## SERVICE BULLETIN

**APPLICABILITY:** 2019-22MY Forester  
2022MY Impreza  
2022MY Crosstrek

**NUMBER:** 12-242-22

**SUBJECT:** Roof Panel Molding – Excessive Gap

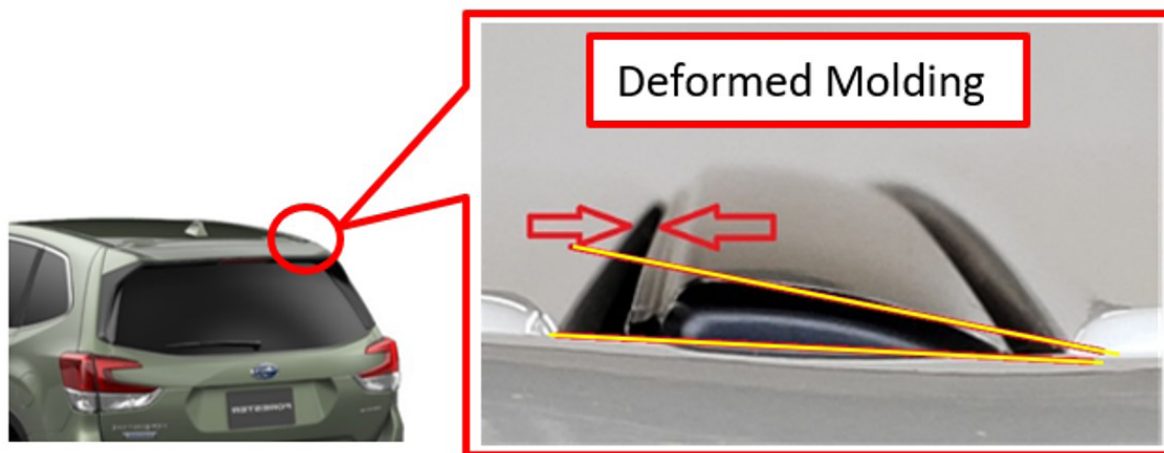
This bulletin announces the shape design change made to the roof molding fasteners to help prevent any deformation of the molding. A customer may experience an excessive gap between the roof molding and the roof panel. The new fasteners have an enhanced shape to help maintain a flat fitment of the roof molding. If this roof molding with excessive gap is reported, replace the affected fasteners with the newly redesigned parts.

**Area of Design Change:**

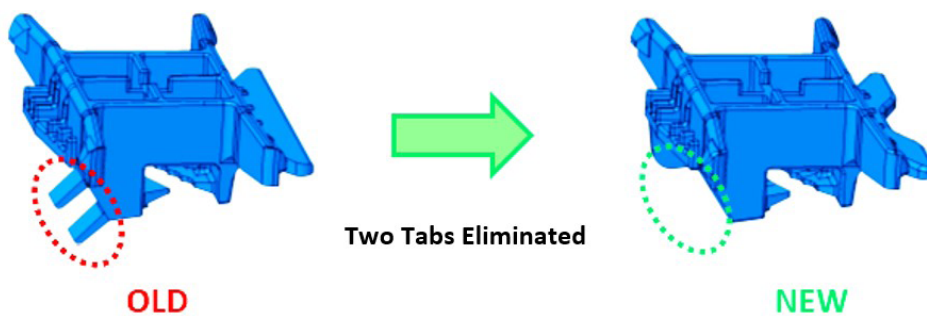
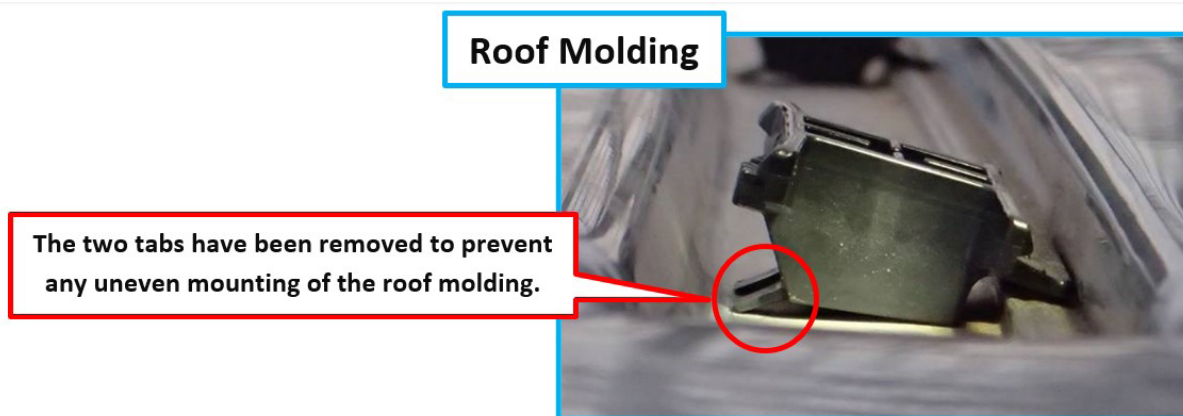
**NOTE:** When deformation is present, it can be seen from all sides.

Model	Part Description	Part Number	Quantity
Forester With Roof Rail	FASTENER	91048FG002	7 Per Side
Forester Without Roof Rail	FASTENER	91048FG002	8 Per Side
Impreza	FASTENER	91048FG002	6 Per Side
Crosstrek	FASTENER	91048FG002	6 Per Side
